# Access Compliance Report

## Public Rights-of-Way

### (Pedestrian Signals)

Intersection ID: N/A	Main Street:	Cross Street: N/A	Location: N/A
ADA ID: BCE121D8BFC7	Signal Type: One Push Button-Non APS	Overall Compliance: No	Severity Score: BTN 1: N/A BTN 2: N/A No BTN: N/A
Codes/Mitigation Info/Possible Solution		Field Measurements/Component Compliance

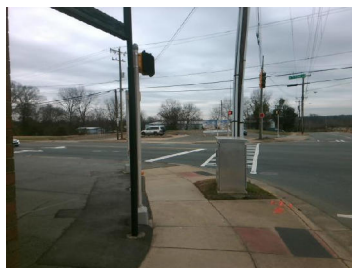
PROW/ADA: TMUTCD 4e.08, R404.3, R406.2

Yes	B 1 Clear Xing Direction?	ClearlyMarked	N/A	B 2 Clear Xing Direction?	N/A
	B 1 Crossing Direction	To N		B 2 Crossing Direction	N/A
Yes	B 1 DistanceTo XWalk (in)	0.0	N/A	B 2 DistanceTo XWalk (in)	N/A
No	B 1 DistanceTo Curb (in)	137.0	N/A	B 2 DistanceTo Curb (in)	N/A
Yes	B 1 Diameter (in)	2.0	N/A	B 2 Diameter (in)	N/A

Possible Solutions: Replace Signal Push Button With APS Button on New Post. Remove & Relocate Sign.
